ADMIRAL

7N2, 7N2A Tuner, 3PA7 Amplifier
Used in Models Y4461,A, Y4462,A,
Y4463,A, Y4481,A, Y4482,A,
Y4483,A, and Y4499,A.

ADMIRAL Model 7N2A FM-AM Stereo Radio Tuner

7N2A SCHEMATIC NOTES

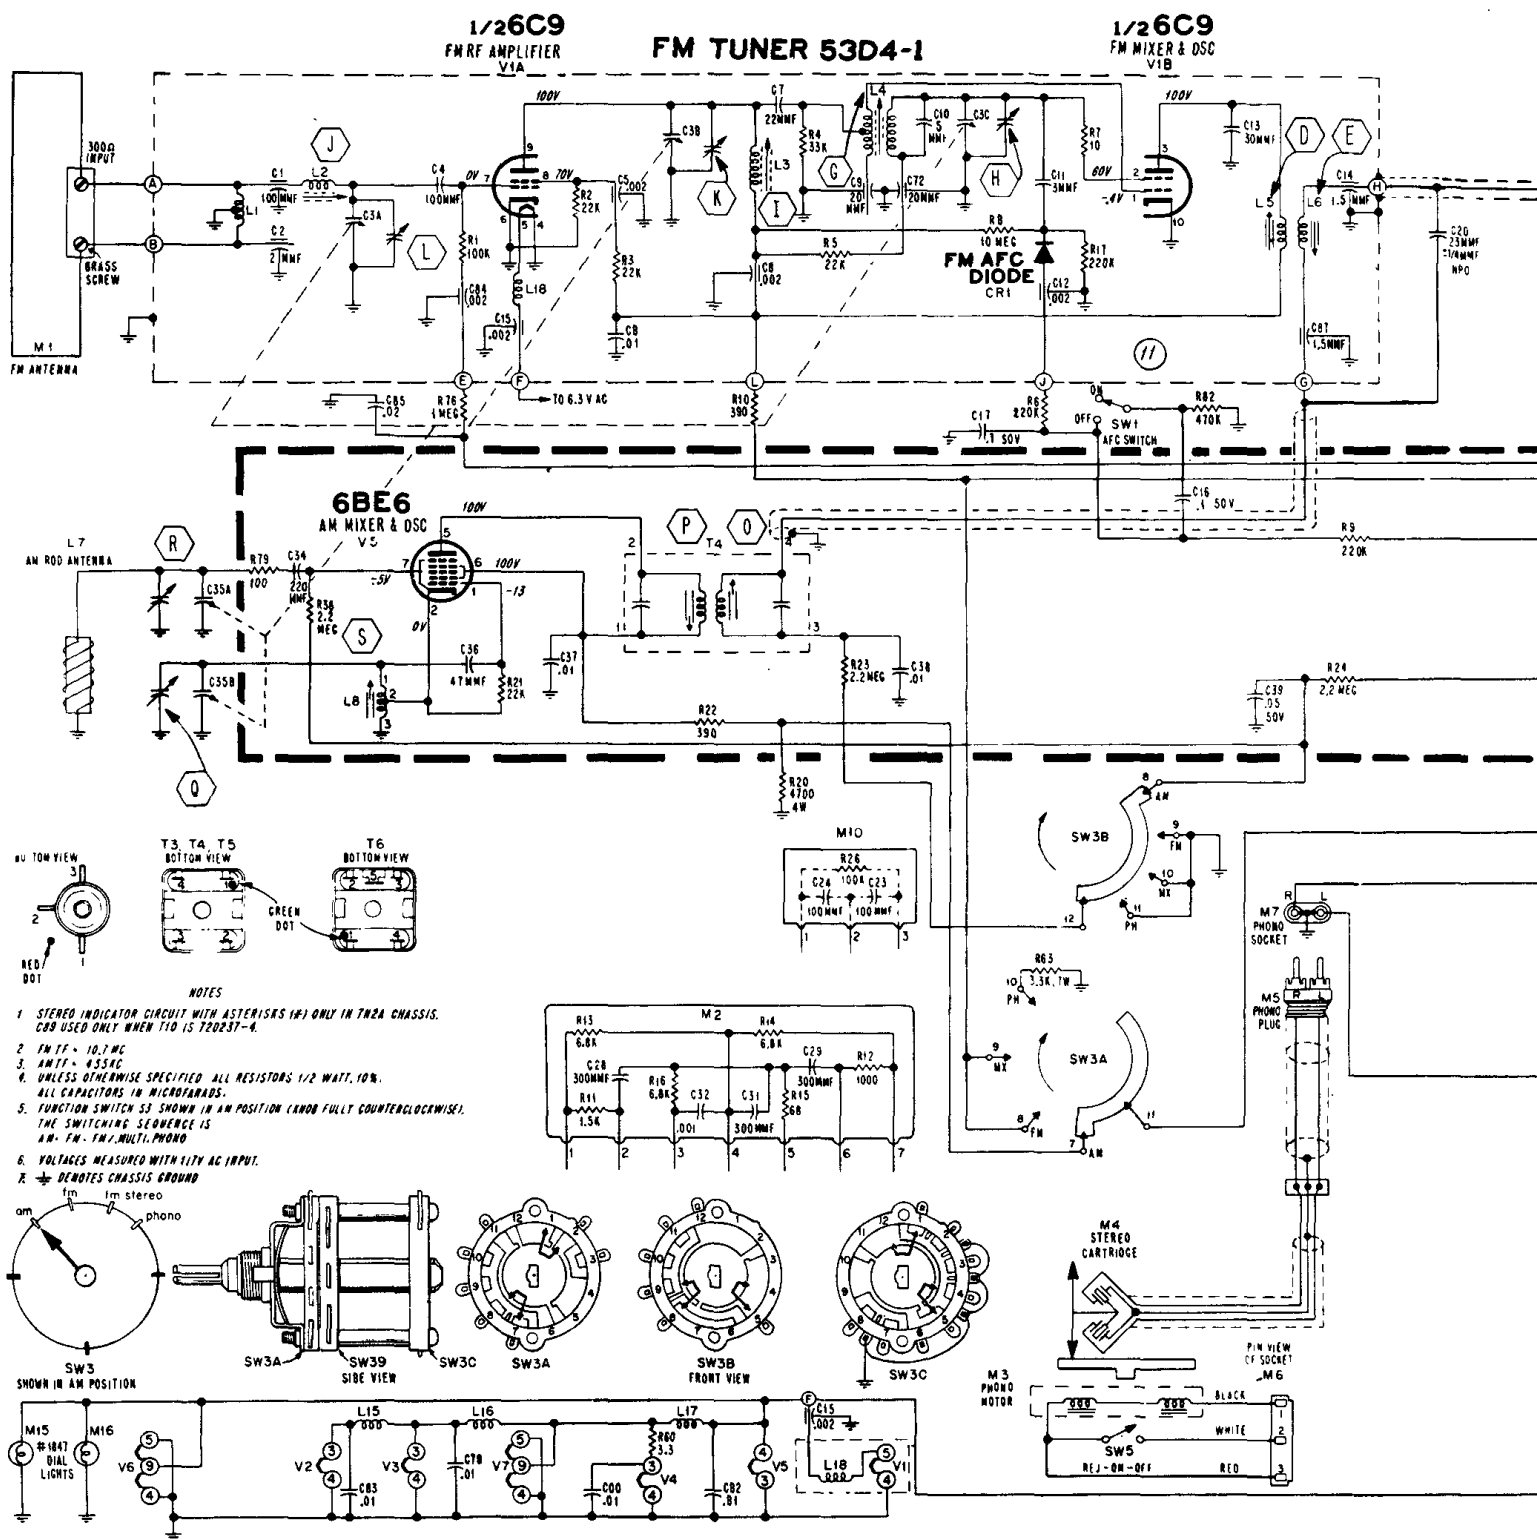
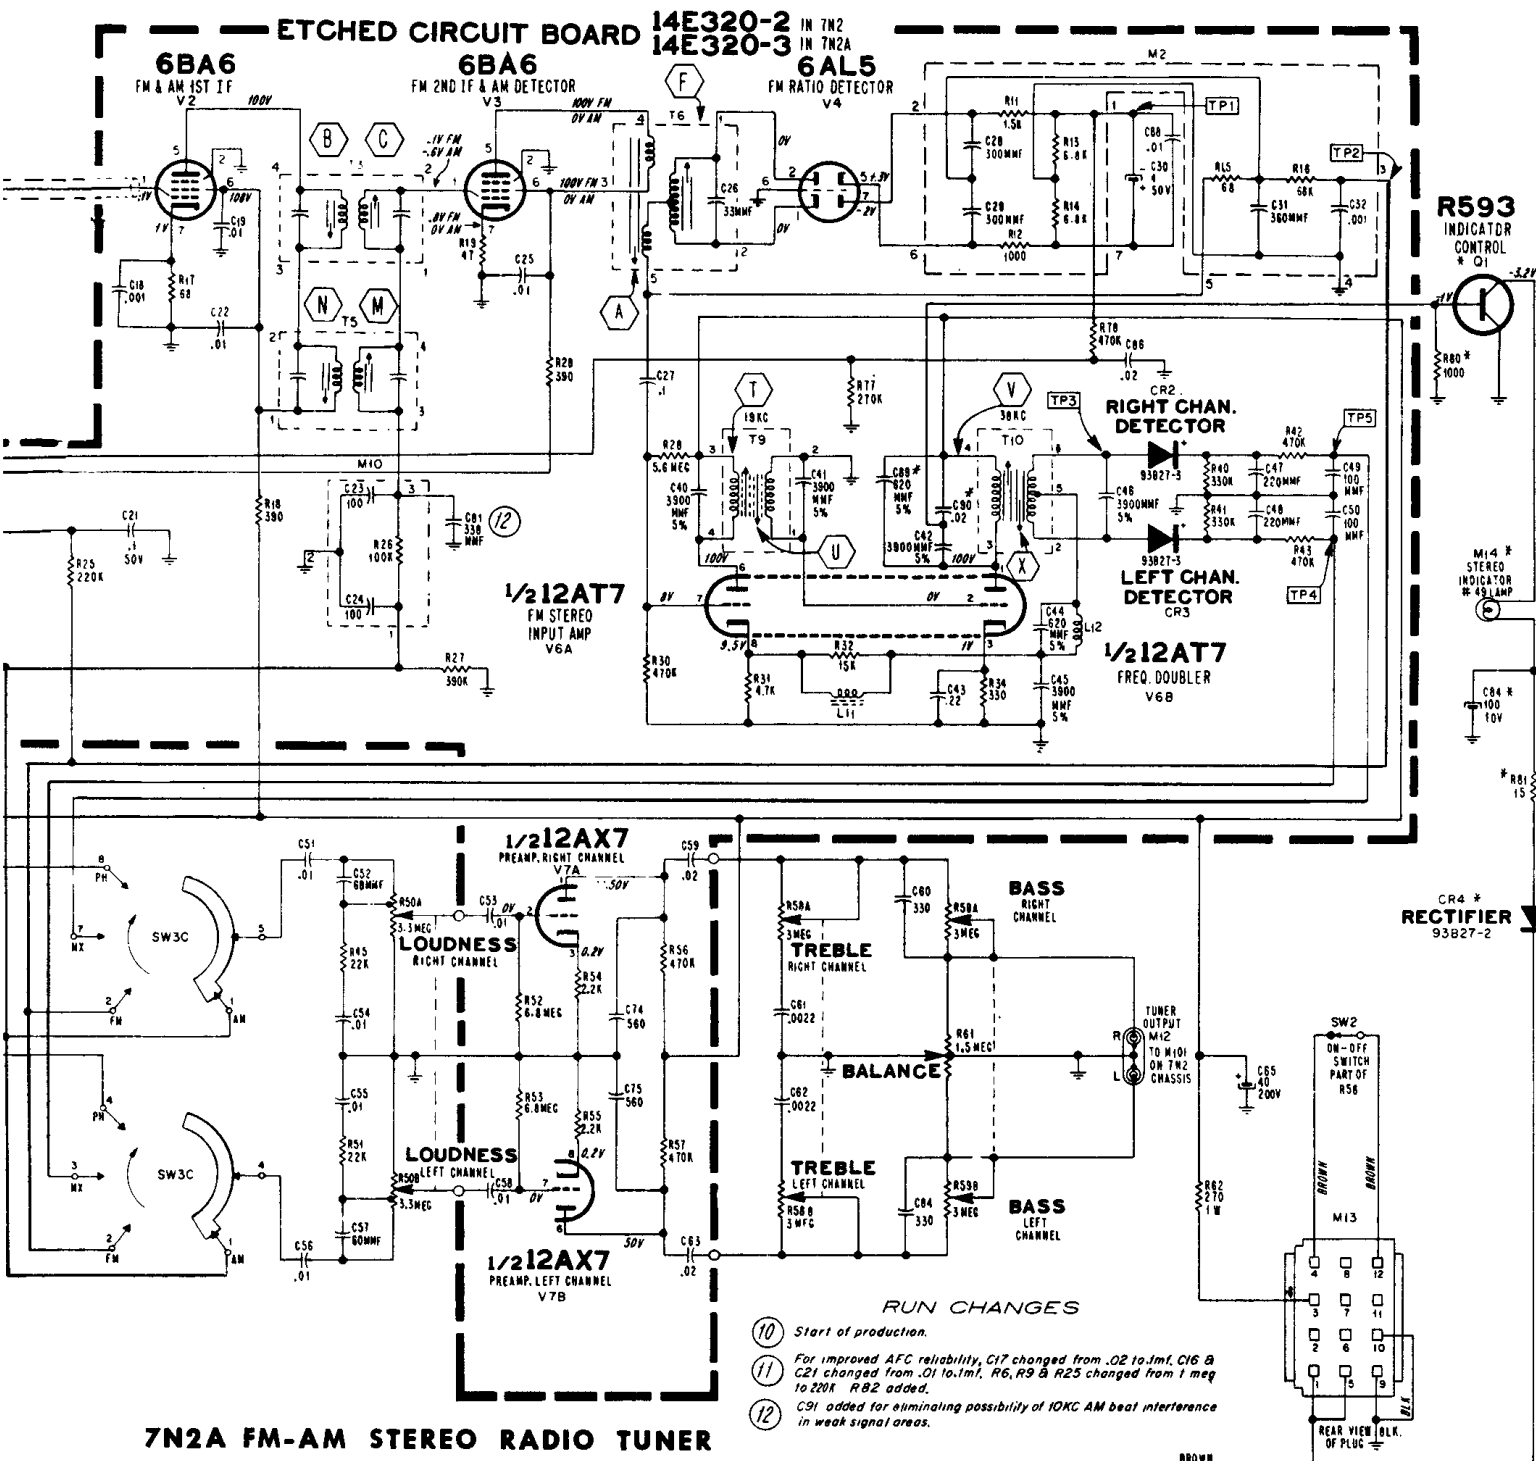
RUN NUMBER CHANGES

7N2 chassis are not stamped with run numbers. 7N2A chassis were stamped RUN 10 at the start of production.

The following changes were made at RUN 11 for improved AFC reliability:

C17 was changed from .02 to .1 mf, 50V ceramic.

C16 and C21 were changed from .01 to .1 mf, 50V ceramic.

R6, R9 and R25 were changed from 1 megohm to 220,000 ohms, 1/2 watt.

R82, 470,000 ohms, 1/2 watt was added.

The following change was made at RUN 12 to eliminate possibility of 10KC AM beat interference in weak signal areas:

Added C91, 330 mmf ceramic disc.
